विषय:- खरगोन एवं खण्डवा जिले में इंदौर-एदलाबाद (धनगांव से बोरगांव सेक्शन) के फोरलेन निर्माण/चौडीकरण हेतु बडवाह वनमण्डल की 3.20 हेक्टेयर वनभूमि एवं खण्डवा वनमण्डल की 0.477 हेक्टेयर वनभूमि तथा 0.461 हेक्टेयर राजस्व वनभूमि कुल 4.138 हेक्टेयर वनभूमि भारतीय राष्ट्रीय राजमार्ग प्राधिकरण, खण्डवा को उपयोग पर देने बाबत।

No. NHAI/PIU-KNW/NH-347BG/PKG-IV/FC/2022-23/1185

Sub: 4- laning of Dhangaon Boregaon section of NH-347BG and NH-753L from Km. 81+000 to Km. 139+000 on HAM mode under Bharatmala Pariyojana in the State of Madhya Pradesh - **Submission of Compliance of EDS raised by IRO regarding Forest Diversion proposal to an extent of 4.138 Ha. - Proposal No. FP/MP/ROAD/152561/2022 - Reg**

COMPONENT WISE BREAKUP OF LAND REQUIRED AND AREA CALCULATION

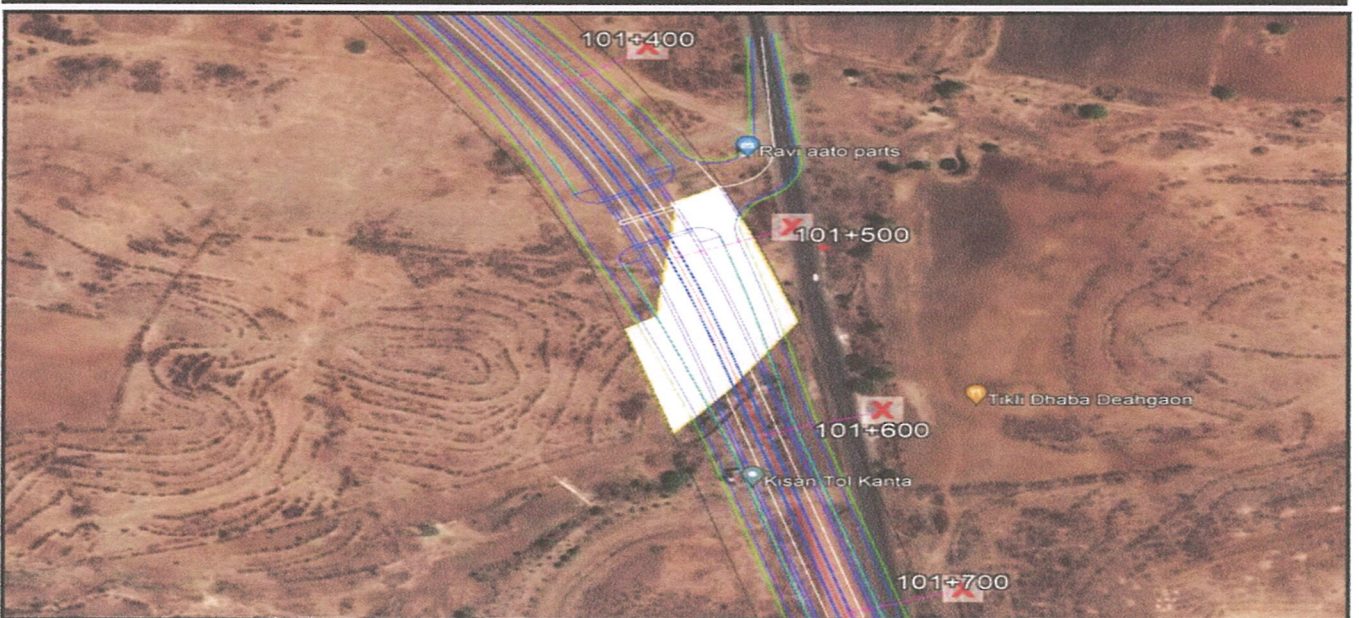
5.	Component wise breakup of land required and component wise area calculation with the layout plan is required.	Component wise breakup of land is attached herewith along with layout plan

S.NO	COMPONENT	LENGTH	WIDTH	AREA IN HA	REMARK
1	ROAD	1454.33	Varies	4.138	
Total Land Required				4.138

Component	From	To	Length in M	Avg. Width in m	Required Area in Ha
Barwah Division					
Road	81+000	82+000	1069	30	3.207
Khandwa Division					
Road	101+500	101+600	78	60	0.47
Road	134+300	134+700	307.33	15	0.461
Khandwa Division Sub Total			385.33	75	0.929
Barwah + Khandwa Divison			1454.33	90	1.390

RF No	From	To	Length in M	Avg. Width in m	Required Area in Ha
Barwah Division					
291	81+000	82+000	1069	30	3.207
Khandwa Division					
U-663	101+500	101+600	78	60	0.47
Revenue Forest	134+300	134+700	307.33	15	0.461
Khandwa Division Sub Total			385.33	75	0.929
Barwah + Khandwa Divison			1454.33	90	1.390
